## Section 3

# Revisions to the DSEIR

This section shows the revisions that have been made to the March 2003 DSEIR for the BART WSX project to provide further clarification or in response to comments received on the DSEIR. The revisions are presented in the consecutive order in which they appear in the DSEIR. Text in standard print is original text from the draft EIR. Underscored (underscored) text indicates additions to the original text, and strikethrough (~~strikethrough~~) text indicates deletions to the original text.

**Figure ES-2  
2003 Proposed Project**

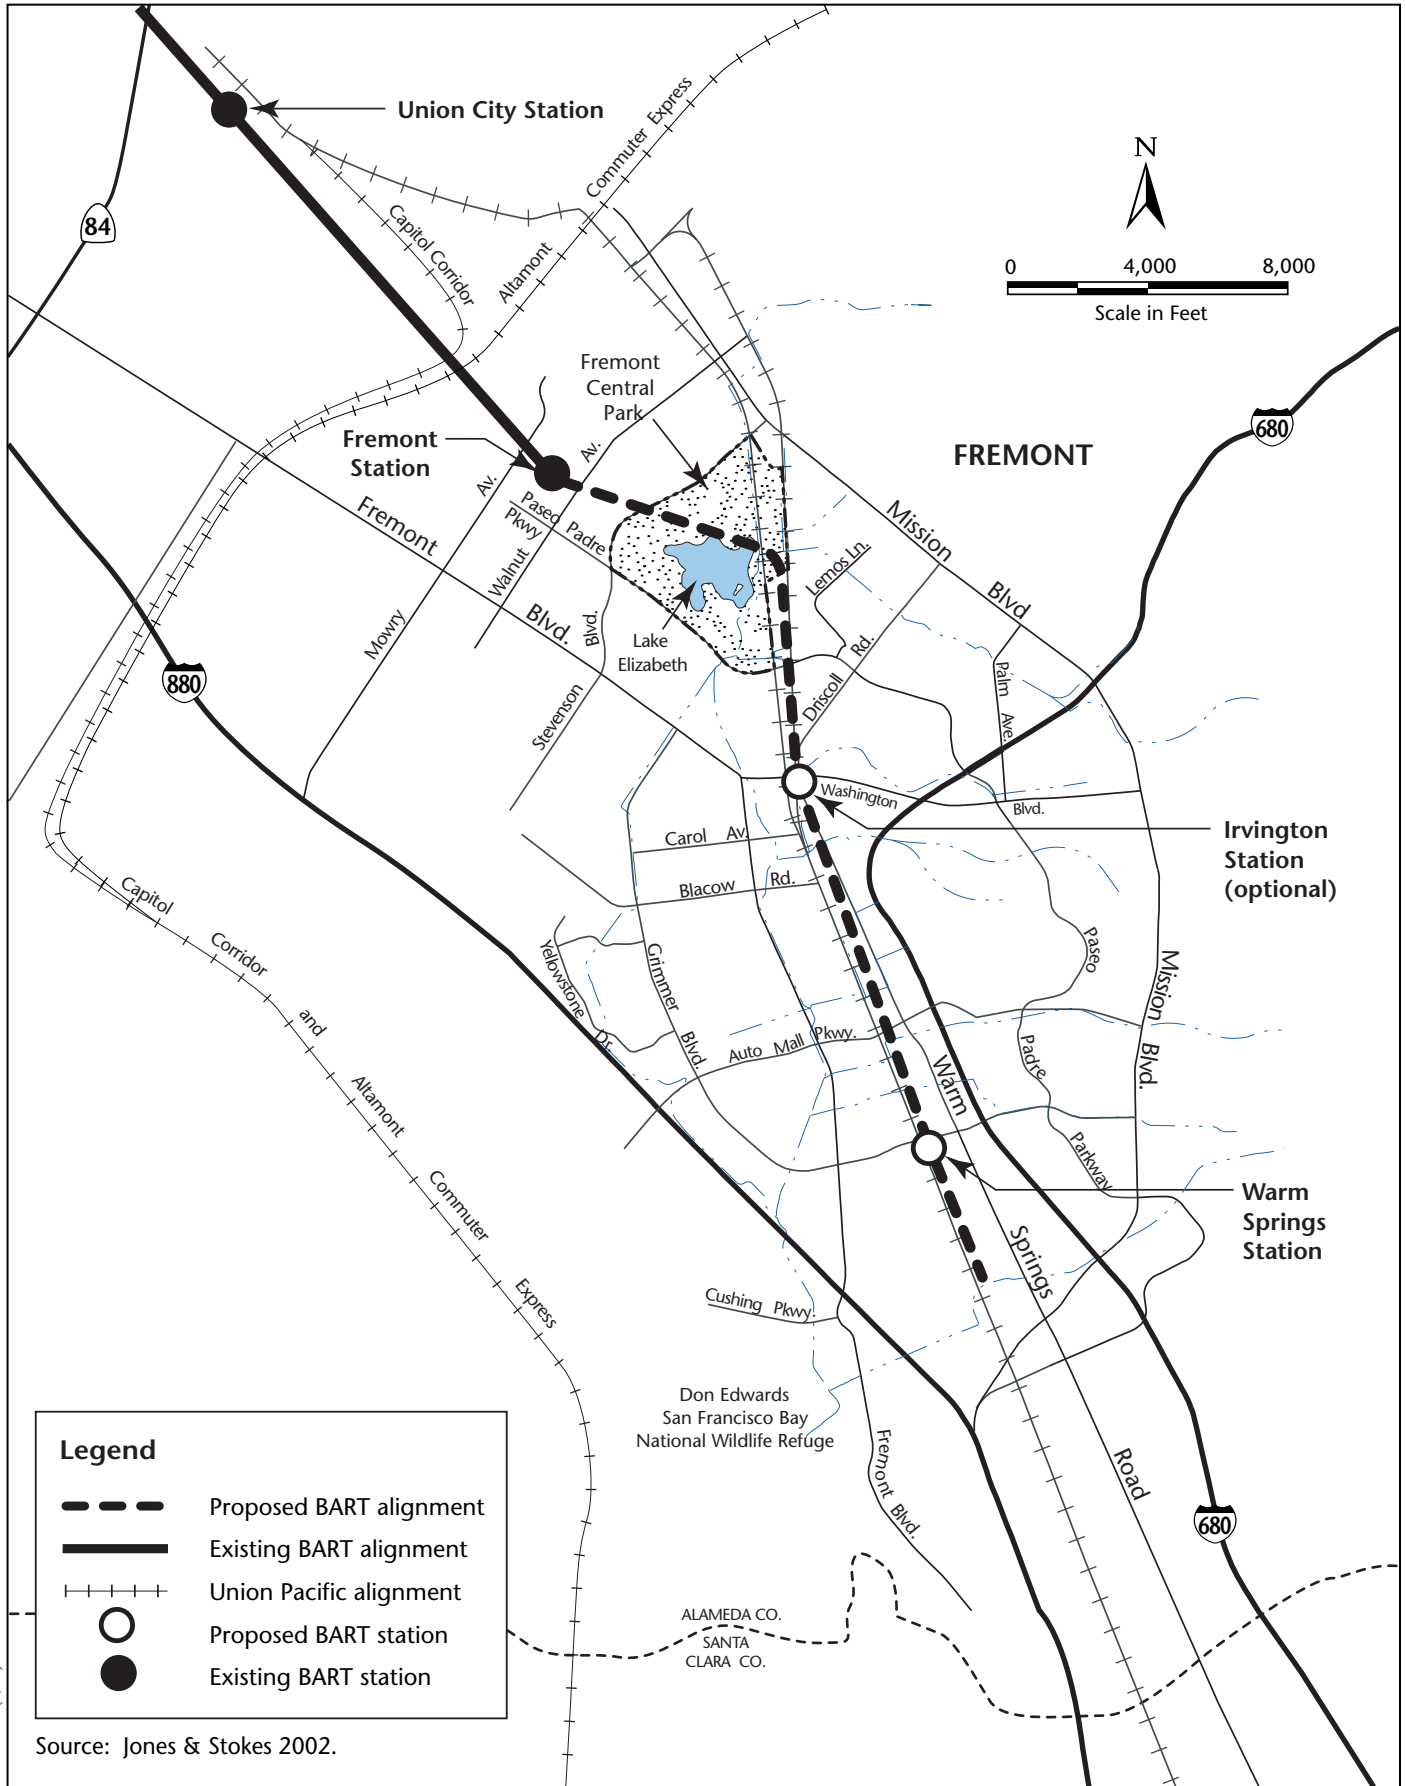
Figure ES-2 in the DSEIR incorrectly labeled the Capitol Corridor intercity rail service alignment as the Altamont Commuter Express (ACE) alignment. The incorrect label is hereby changed to Capitol Corridor in this FSEIR.

**Figure 3.7-4 - Viewpoint 2**

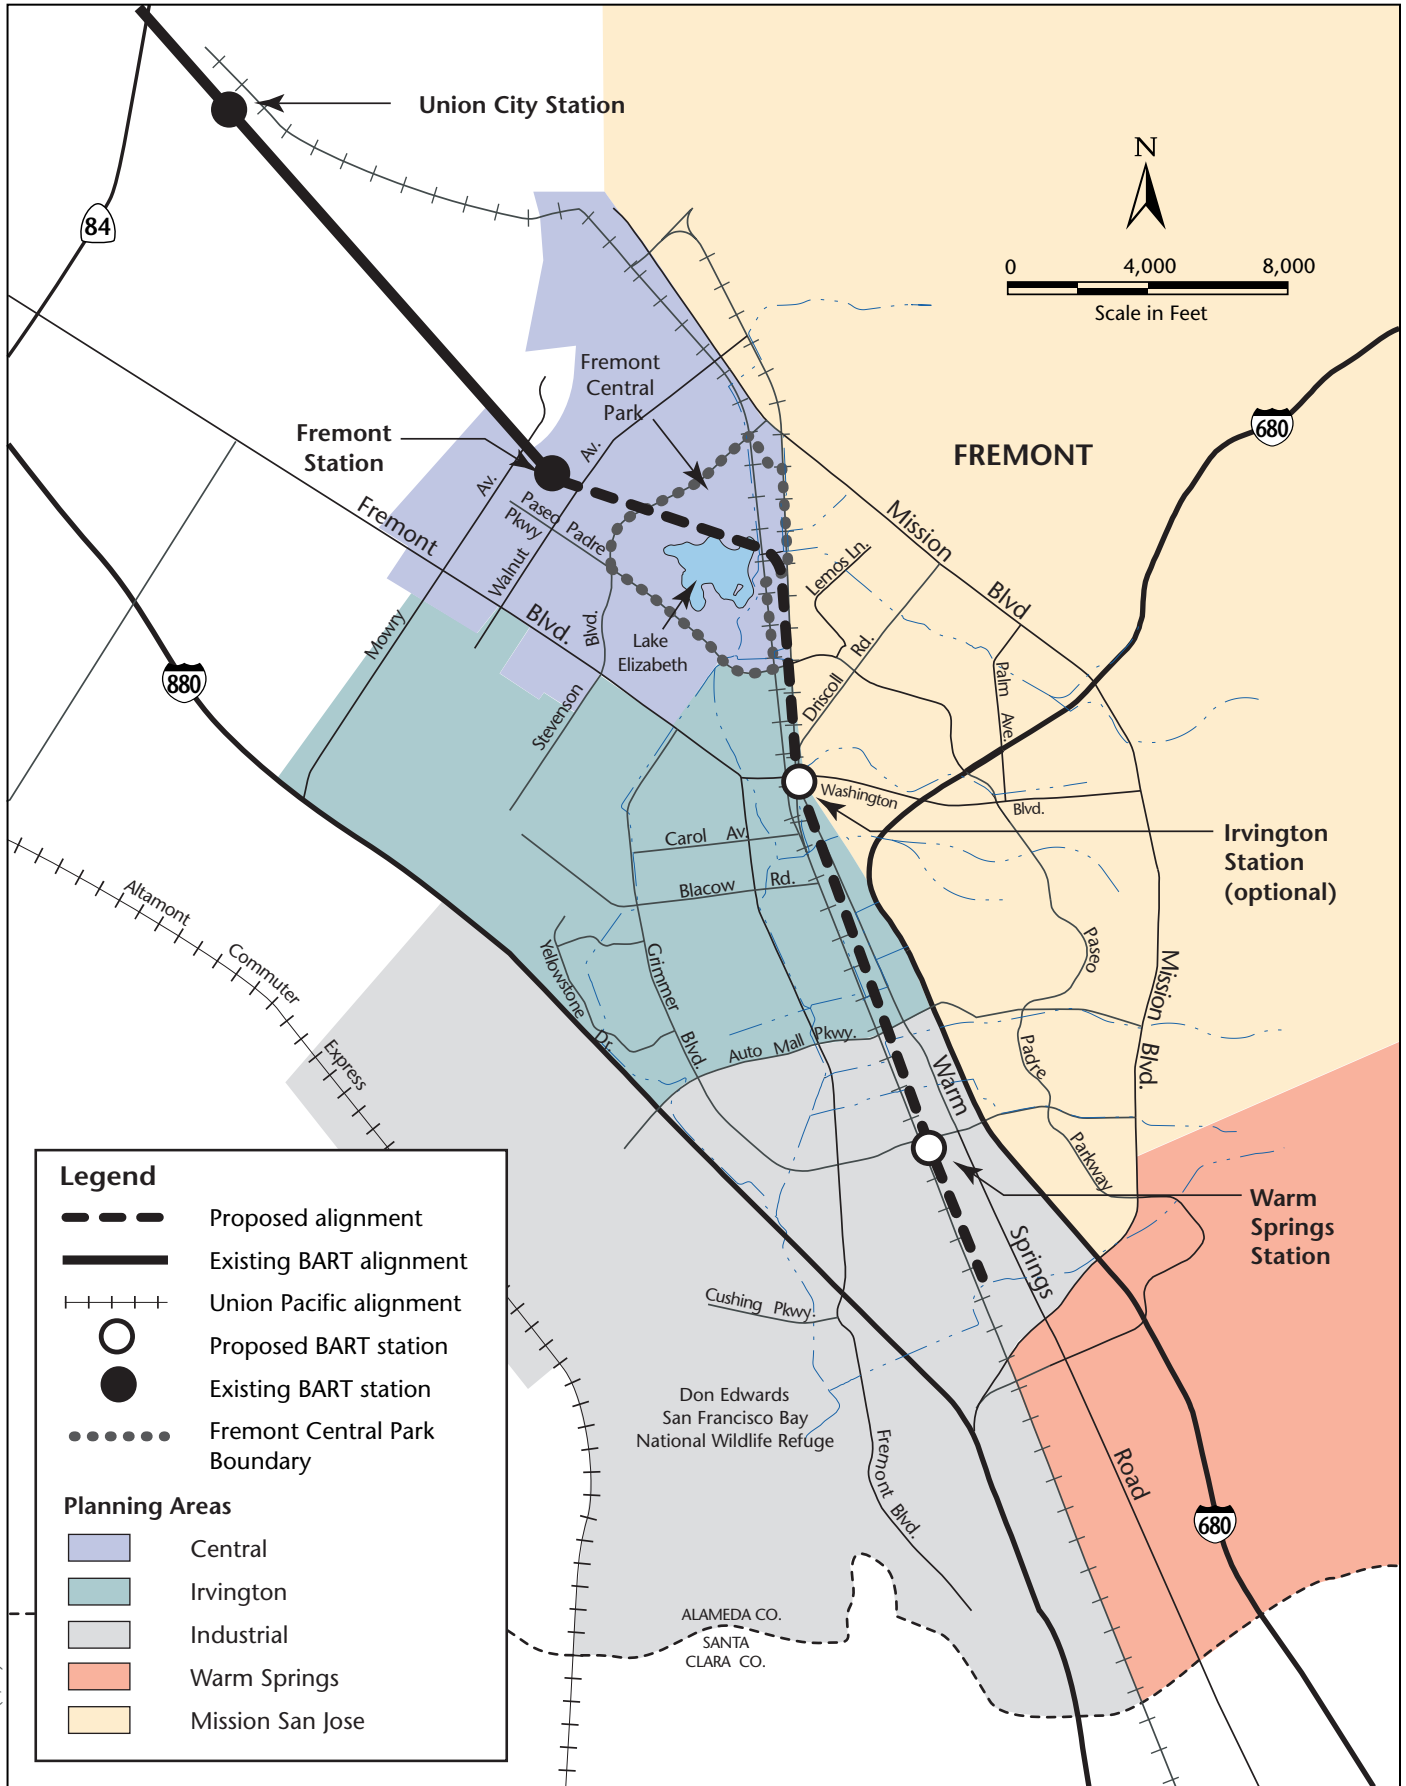
Figure 3.7-4 on page 3.7-14 of the DSEIR has been revised to show a simulation of how a noise barrier would look if placed on the BART embankment.

**Figure 3.5-2**  
**Planning Areas Affected by**  
**Proposed Project Alignment**

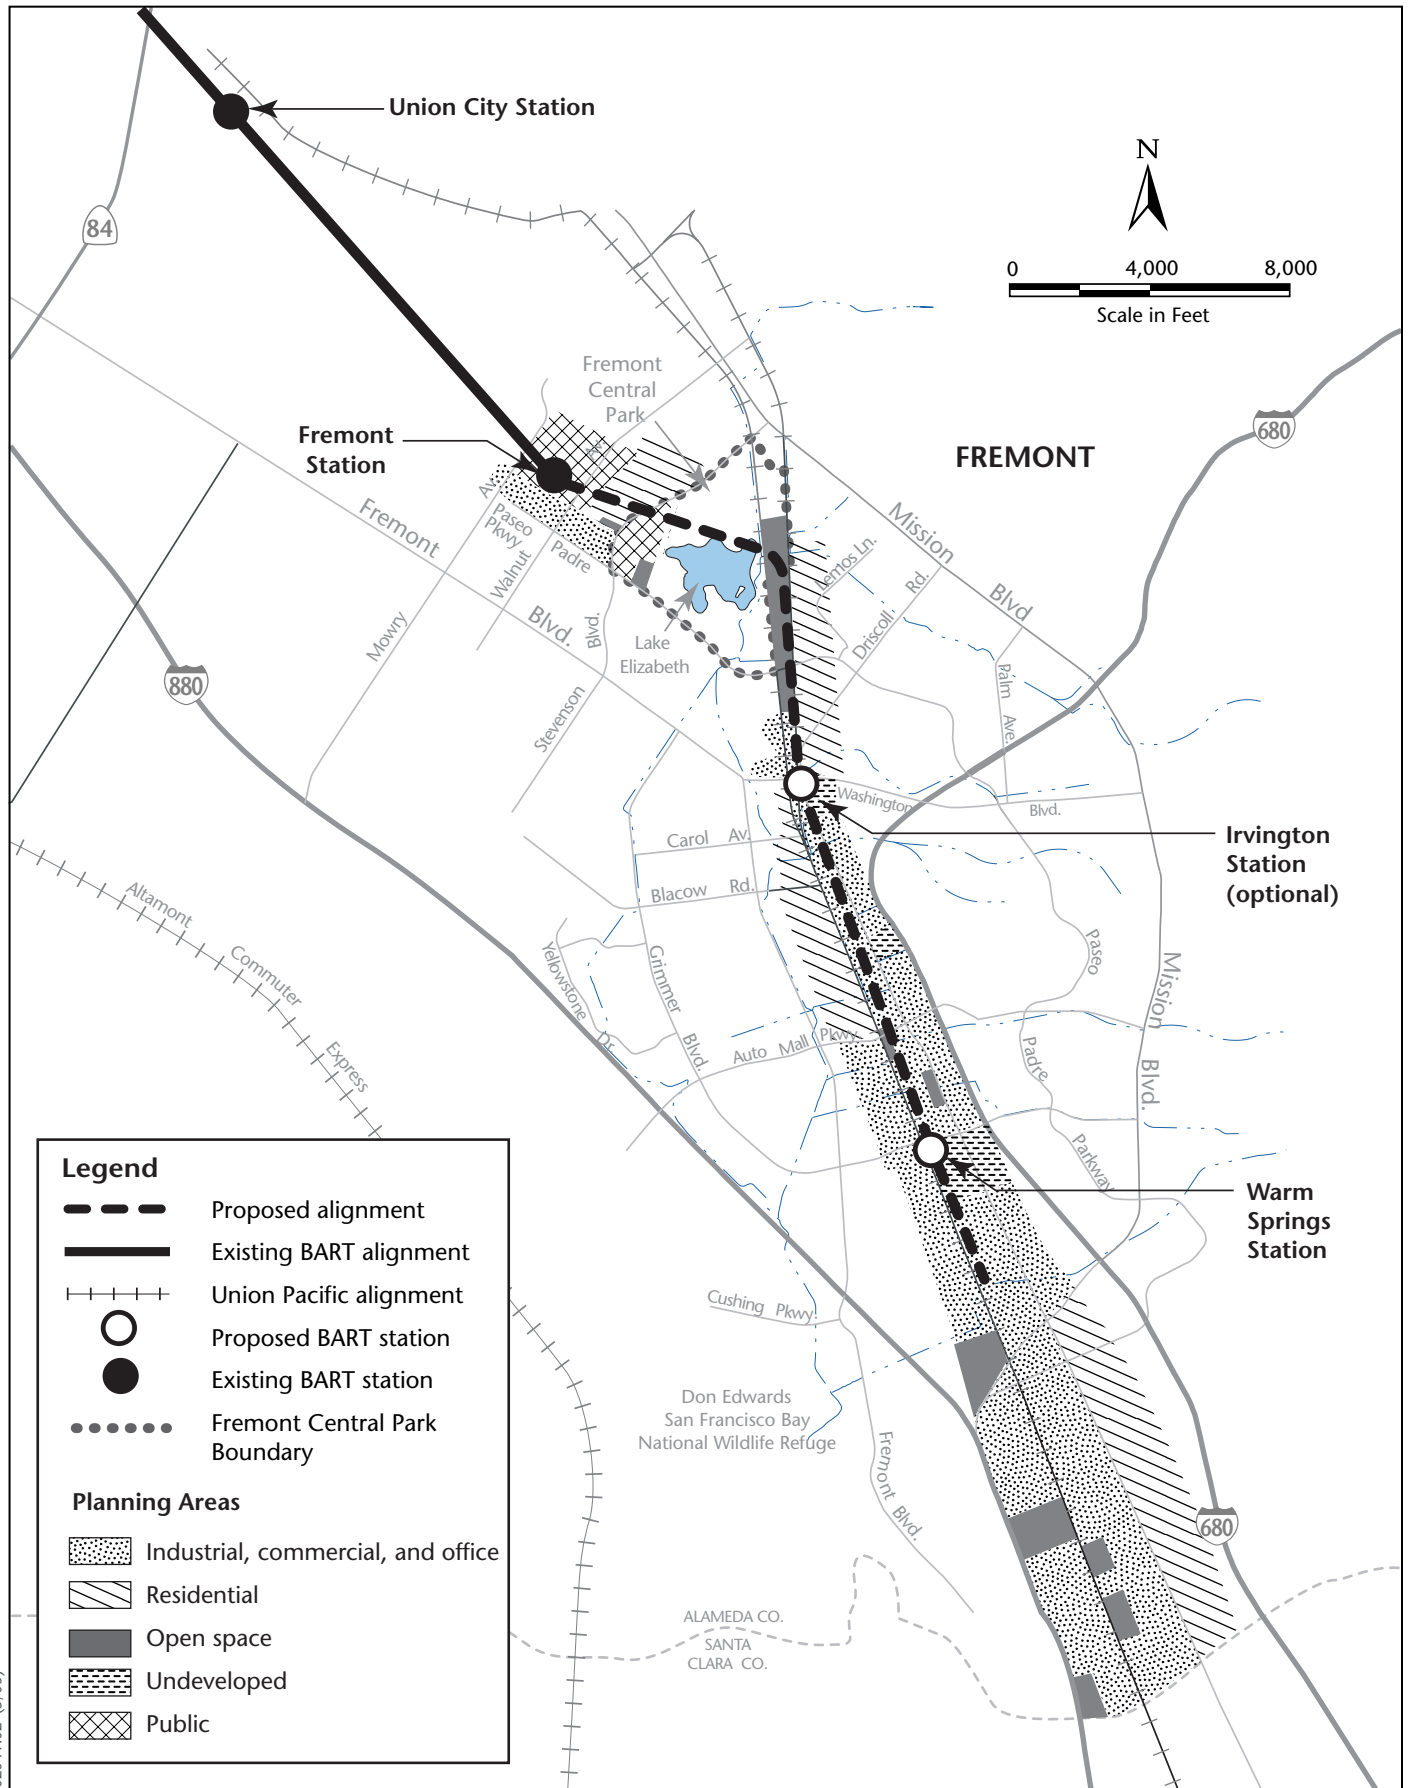
The Newark label in Figure 3.5-2 of the DSEIR was placed in the wrong location. The figure is hereby revised accordingly. The same comment applies to Figures 3.5-3 and 3.5-6, which are also hereby revised accordingly. The same comment also applies to the following figures: 1-2, 1-5, 2-2, 2-3, 3.1-1, 3.10-3, 3.10-4, 3.2-1, 3.3-1, 3.4-2, 3.5-6, and ES-2. The Newark label is hereby removed from each of these figures, but the revised figures are not included here in this FSEIR.

**Figure 5-1  
Proposed Bus Alternative Alignment**

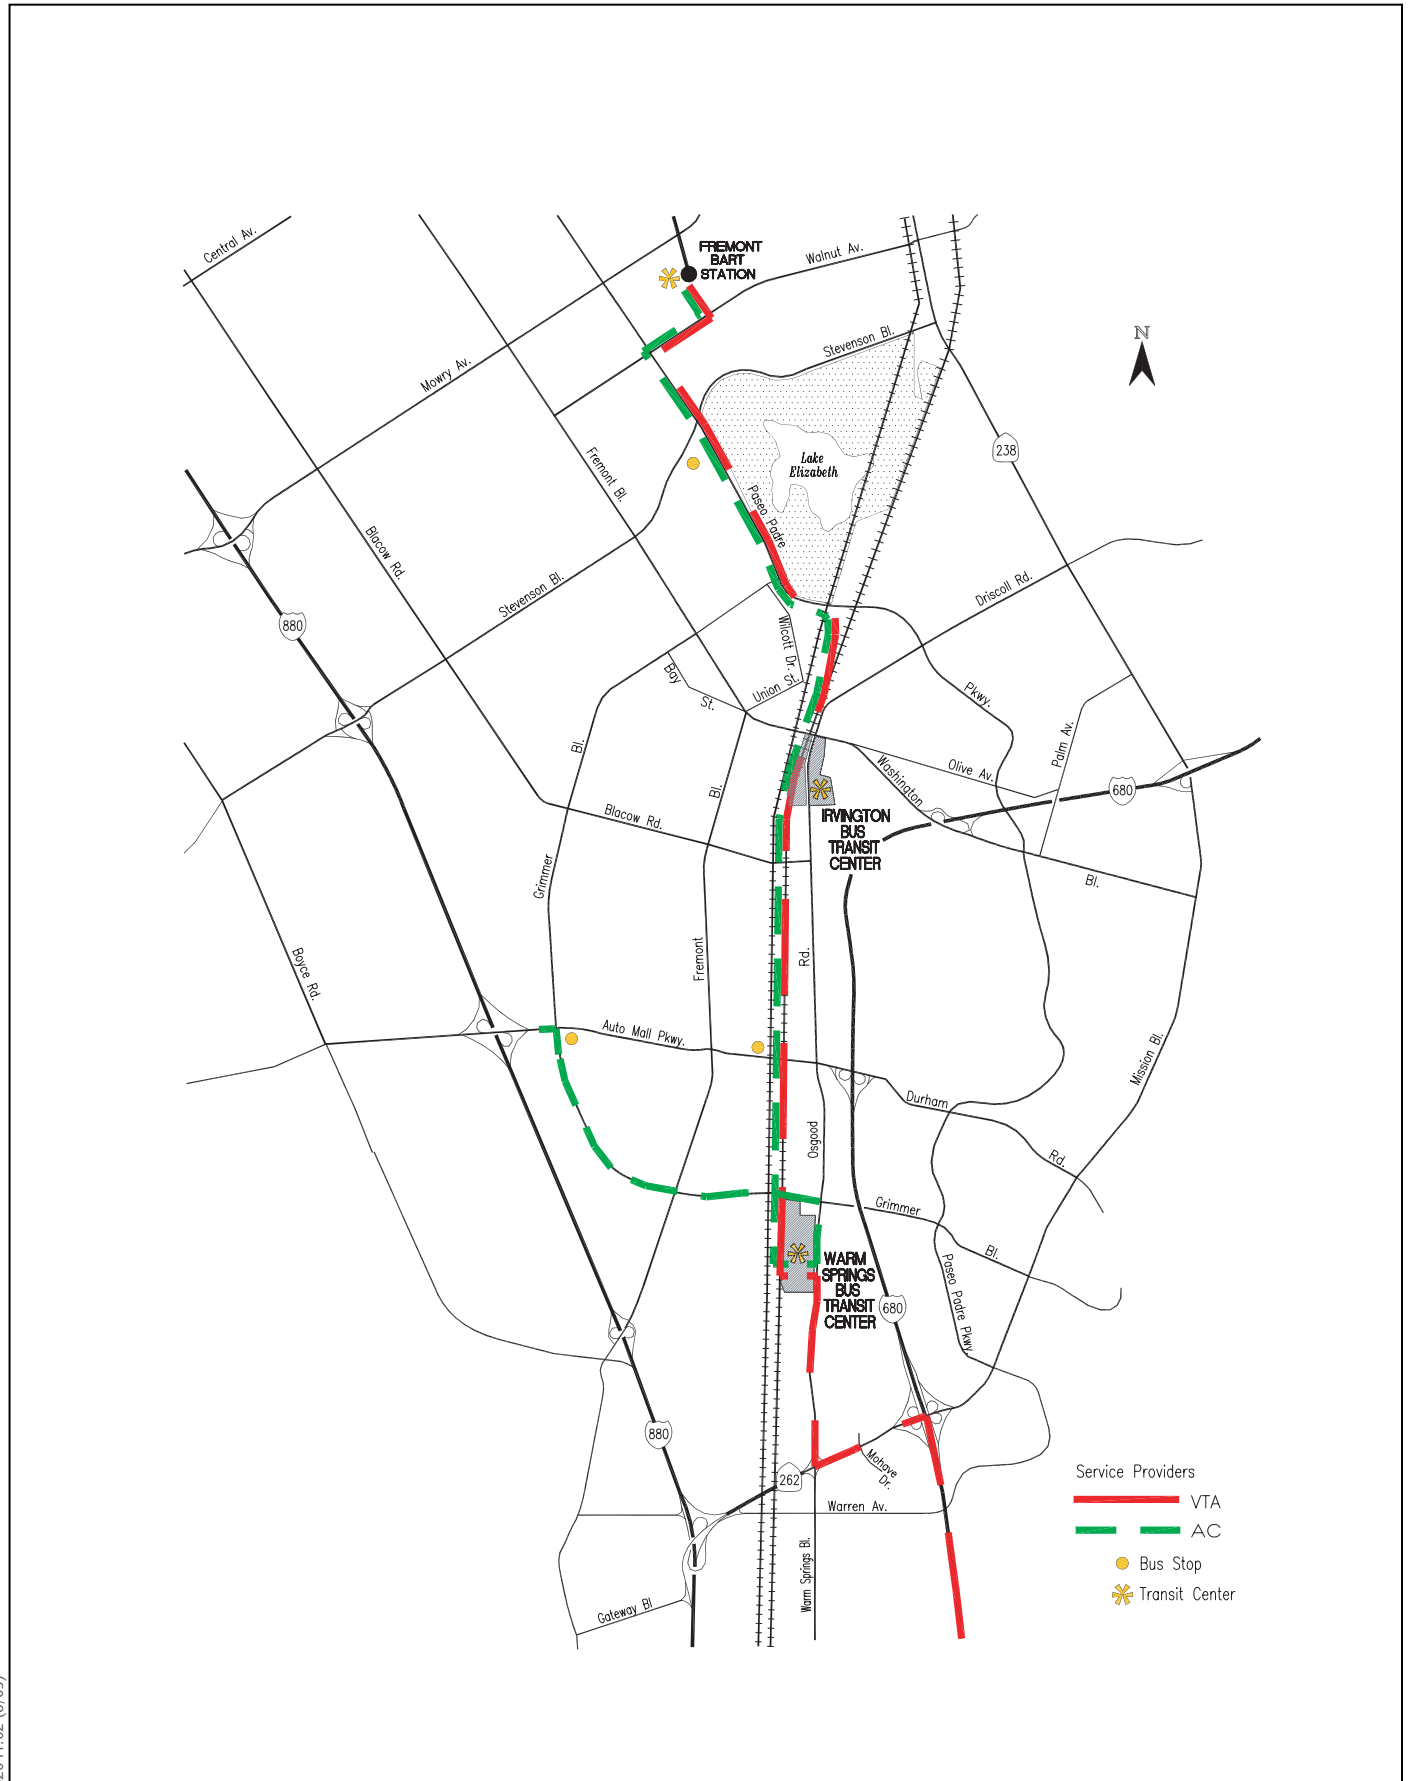
Figure 5-1 has been revised to clarify the alignment for the Bus Alternative and to be consistent with the description of the alternative in the text. Figure 5-1 has been revised in the following ways:

- The title of the Figure 5-1 has been changed from “Proposed Bus Routes” to “Proposed Bus Alternative Alignment.”
- The proposed bus guideway alignment between Paseo Padre Parkway and Washington Boulevard has been clarified to show the bus guideway located between the former SP and former WP alignments in the vicinity of Paseo Padre Parkway and within the former WP alignment further to the south.
- The areas on the figure labeled “Irvington Station” and “Warm Springs Station” have been relabeled as “Irvington Transit Center” and “Warm Springs Transit Center,” respectively.
- The footprint for the Irvington Transit Center has been clarified to show that it also would occupy area on the east side of Osgood Road.

The illustration of the Warm Springs Transit Center has been clarified to indicate that the bus guideway would extend only along a portion of the Warm Springs Transit Center and not along the entire western perimeter. In addition, buses from VTA and AC Transit would access the Warm Springs Transit Center at an entrance midway along the site’s Warm Springs Boulevard frontage, and there would be no bus routes along the southern perimeter of the site.
